5.1 NO. 14 (LOT: 119; D/P: 1223) FRANKLIN STREET, LEEDERVILLE - PROPOSED THREE GROUPED DWELLINGS

RECOMMENDATION:

That Council, in accordance with the provisions of the City of Vincent Local Planning Scheme No. 2 and the Metropolitan Region Scheme, APPROVES the application for Three Grouped Dwellings at No. 14 (Lot: 119; D/P: 1223) Franklin Street, Leederville, in accordance with the plans shown in Attachment 2, subject to the following conditions, with the associated determination advice notes in Attachment 9:

Original unit 1 west elevation

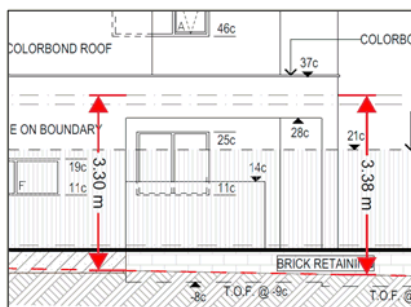
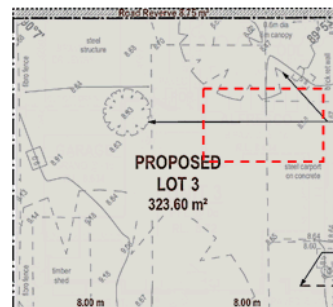
RFI

Response The plans have been amended to reduce the upper floor wall heights no less than 6m through change in roof form. The ground floor alfresco and scullery wall height does not exceed 3.5m (and all habitable spaces will be screened by the dividing fence) and therefore does not require more than a 1.5m setback. The reduced setback requirements are as follows:

Amended unit 1 west elevation

Boundary wall (original)

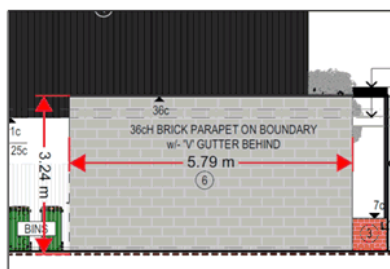
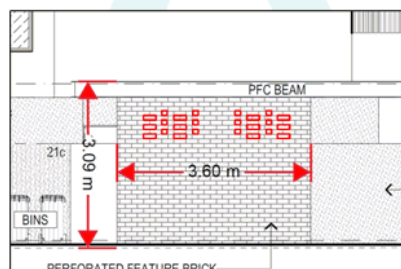
RFI Proposed unit 1 garage boundary wall with an average height of 3.3m in lieu of 3.0m permitted to the western lot boundary.

Response The boundary wall has been amended, reduced in height and length as part of the changes to replace the proposed garages with carports. The wall length and height have been reduced to 3.6m and 3.1m respectively. There is limited scope for impact, as there appears to be only one window which will be adjacent to the wall on the affected property, and this room also includes significant windows within the façade, which will mitigate potential loss of light and ventilation as a result of the boundary wall. The adjacent space is otherwise inactive and does not provide any function for the dwelling.

Wall height 1 (red) / Wall height 2 (orange) / Highest point of building (blue)

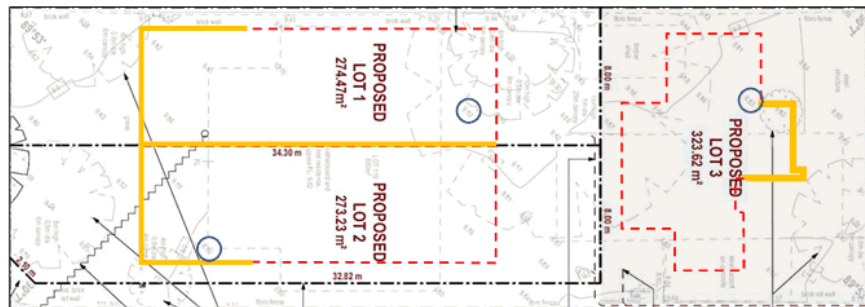
- RFI**
- Proposed unit 1 with a skillion roof height of 6.5m to the low side and 7.3m to the high side in lieu of 6m and 7m permitted respectively.

Response The amended roof form has resulted in considerably lower building wall heights, the table below stipulates the natural ground level where a 6m building height would result based off of the wall heights proposed which can be cross referenced against the diagram below to determine building height.
